ADA Curb Ramp New Construction Inspection Form (Parallel)

NW 317th PI	24952.54			NW North Ave
North-South Road Name	Project No.	Sheet No.	Intersection No.	East-West Road Name
Calibration Date 10/22/2024 (mm/dd/yy)

PARALLEL RAMP (PL)

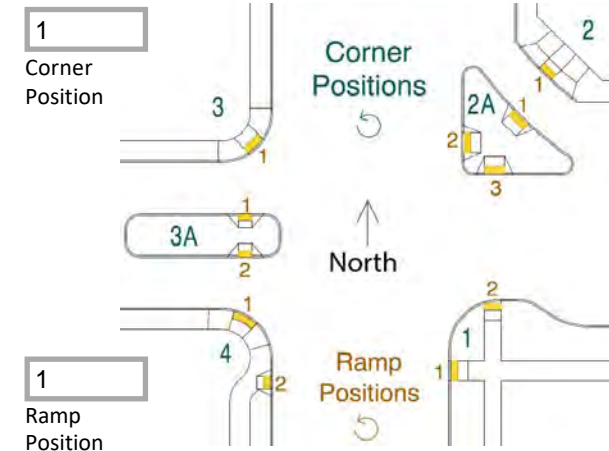
RAMP RUN 1	Pass	Fail
Running Slope 1	2.0 $\leq 2.0\%$ <input checked="" type="checkbox"/> $> 2.0\%$ <input type="checkbox"/>	
Cross Slope 1	2.9 $\leq 2.0\%$ <input type="checkbox"/> $> 2.0\%$ <input checked="" type="checkbox"/>	
Detectable Warning	Y Y <input checked="" type="checkbox"/> N <input type="checkbox"/>	
Lip Height	0 $\leq 1/4"$ <input checked="" type="checkbox"/> $> 1/4"$ <input type="checkbox"/>	
Gutter Flow Slope	3.9 $\leq *$ <input type="checkbox"/> $> *$ <input checked="" type="checkbox"/>	
Curb Running Slope (avg)	<input type="checkbox"/> 3.44 $\leq 8.3\%$ <input checked="" type="checkbox"/> $> 8.3\%$ <input type="checkbox"/>	
Counter Slope (+/-)*2	6 $\leq 5.0\% $ <input type="checkbox"/> $> 5.0\% $ <input type="checkbox"/>	
Det. warning full width of ramp	Y Y <input checked="" type="checkbox"/> N <input type="checkbox"/>

RAMP RUN 2	Pass	Fail
Running Slope 2	9.6 $\leq 8.3\%$ <input type="checkbox"/> $> 8.3\%$ <input checked="" type="checkbox"/>	
Length 2	7.95	
Cross Slope 2	$\leq 2.0\%$ <input type="checkbox"/> $> 2.0\%$ <input checked="" type="checkbox"/>
